**Guy Smith Stadium Improvements Phase 2
Addendum No. 02**

Project Name: Guy Smith Stadium Improvements	Project No.: RFP#23-24-19
Prepared By: Mark Nottingham	Date: 10-12-2023

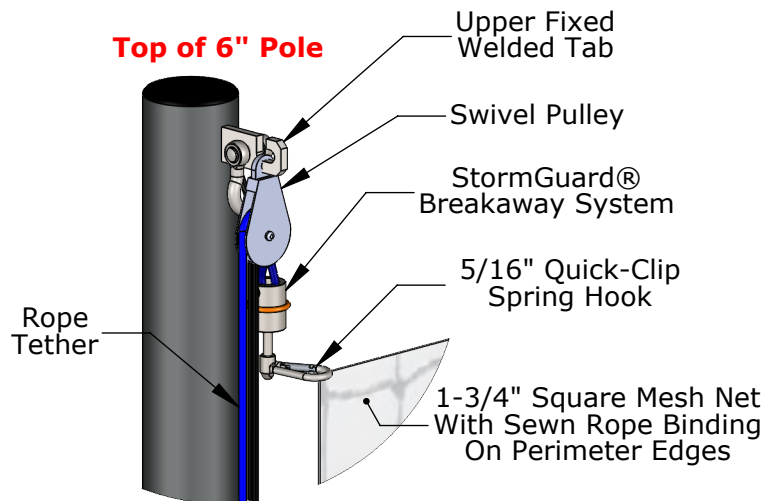
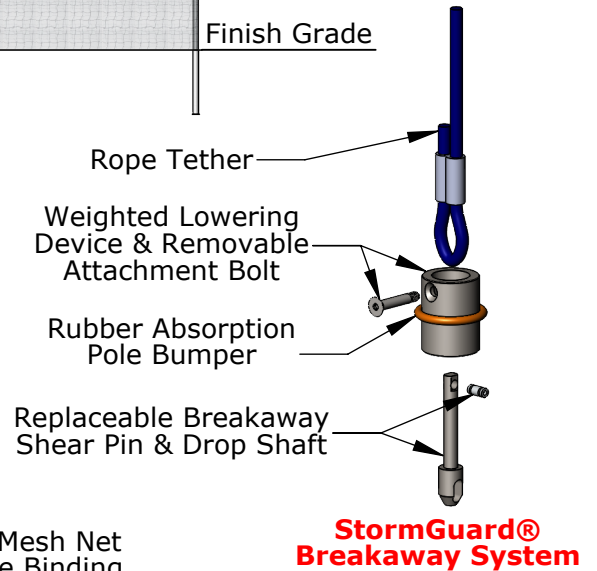
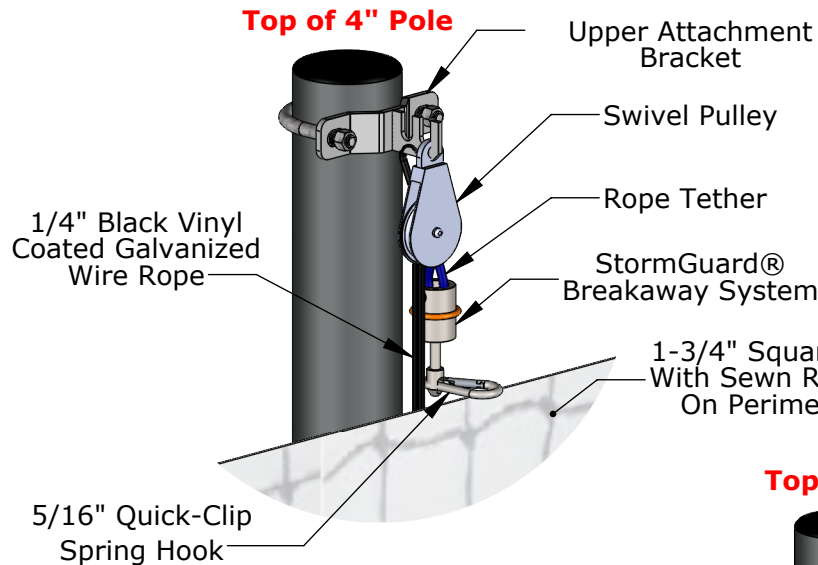
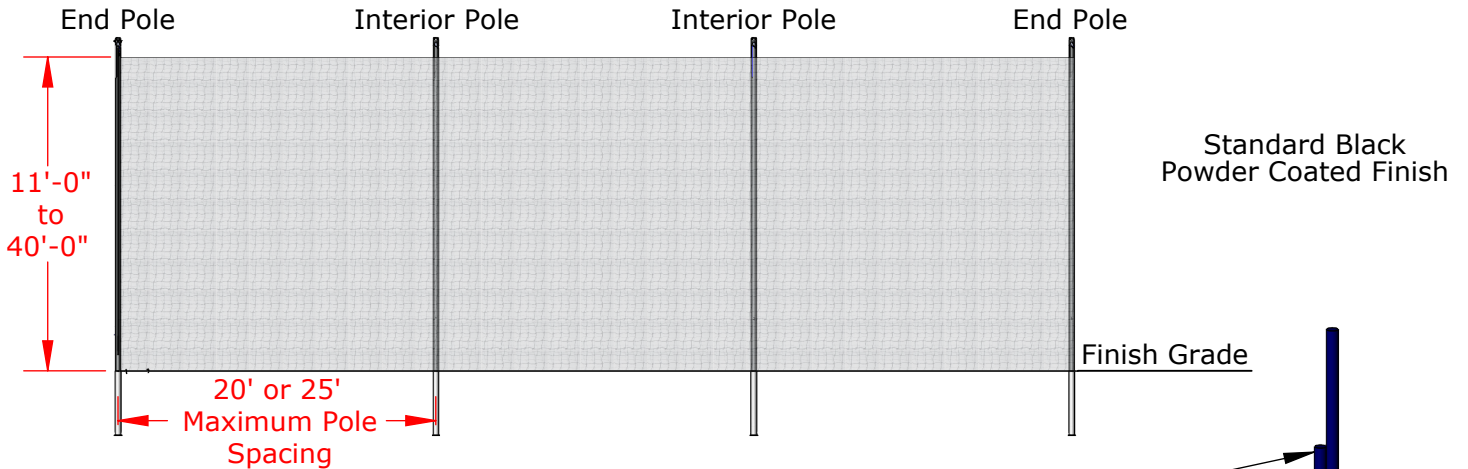
1 - Drawing A111 shows us to install sport netting along the 1st base line. It appears that the intent is to install (2) new poles. Are we to tie-into the existing netting where it stops just short of the dugout? If so, can you confirm that the existing structure can support the new netting? Is there any need to replace the netting along the backstop?

2 - Are there any design parameters around that. Netting? How high does it need to be, does it need to be removable or is fixed acceptable.

See attached sketch and supporting information.
